Attachment B – Port Stephens Development Control Plan
Chapter C5 – Multi-dwelling housing or seniors housing assessment table

Figure 1. Side setback exceedance for dwelling TH3.

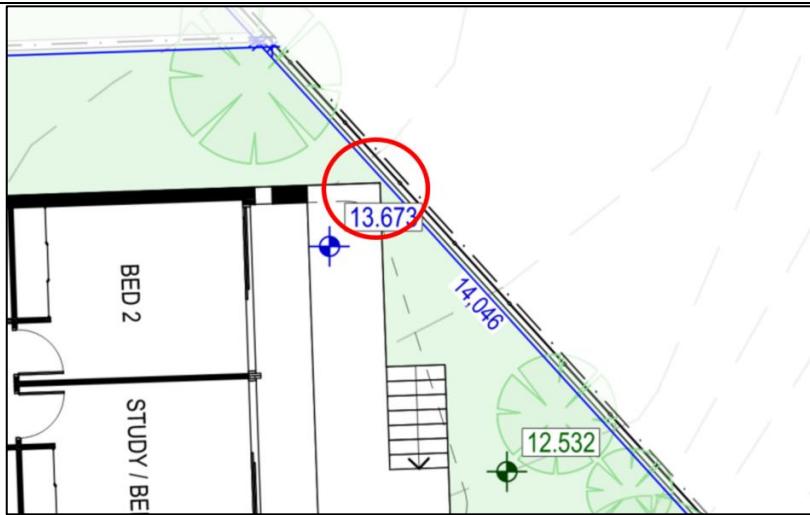
Assessment	N/A
Control	<u>C5.11 – Side setbacks</u> Minimum 0.9m side boundary setback for any part of a building at or below 5.5m in height
Assessment	Eastern Side Setback Along the eastern boundary, all proposed side setbacks comply with the 0.9m setback requirement with the exception of dwelling TH3. The north eastern corner of the terrace on the ground floor of dwelling TH3 is setback 0.3m from the eastern boundary with the neighbouring lot. The remainder of the dwelling exceeds the 0.9m setback with the exceedance limited to the north eastern corner which symptomatic of the lots shape, as shown in Figure 1 below.

TH3 is largely orientated toward the driveway of the lot to the sites east. However, if facing north east, there is the potential to overlook the front of the dwelling to the sites east. To limit potential privacy impacts a privacy screen has been proposed to the terrace's northern façade.

Due to the extent of the proposed encroachment and provision of privacy screening, the variation is supported.
